FIELD INSPECTION

Project Name:	Mountain Valley Pipeline	Inspector:	Matthew Grant
Inspection Date:	Wednesday, August 21, 2019	Project Contact:	Brian Clauto
Spread: Montgomery Co. MP231 AR 276.03 St12235-12197+73	Spread H	Weather (Wet/Dry/Rain):	Dry

FIELD INSPECTION PHOTO LOG

- Fig. 5 St12218+40 waterbar not built to spec

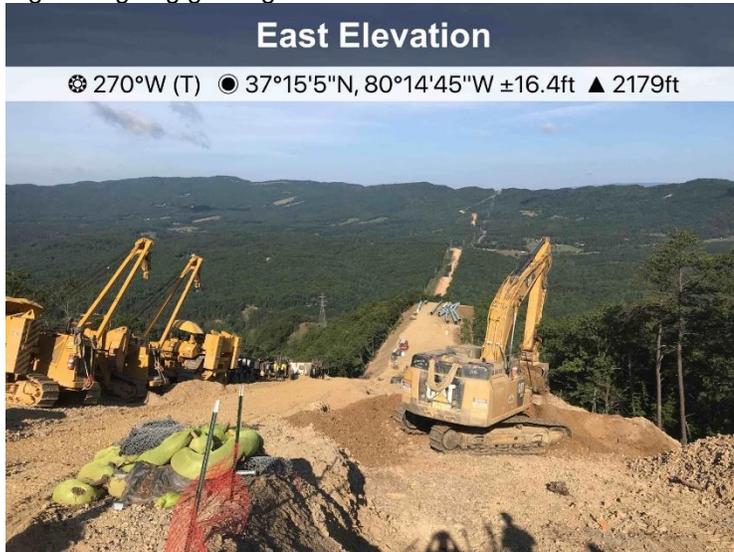
- Fig. 6 St12217+50 waterbar requires maintenance of end treatment and sump

Recommend Corrective Action: Maintain and install all controls per the approved plan and specs
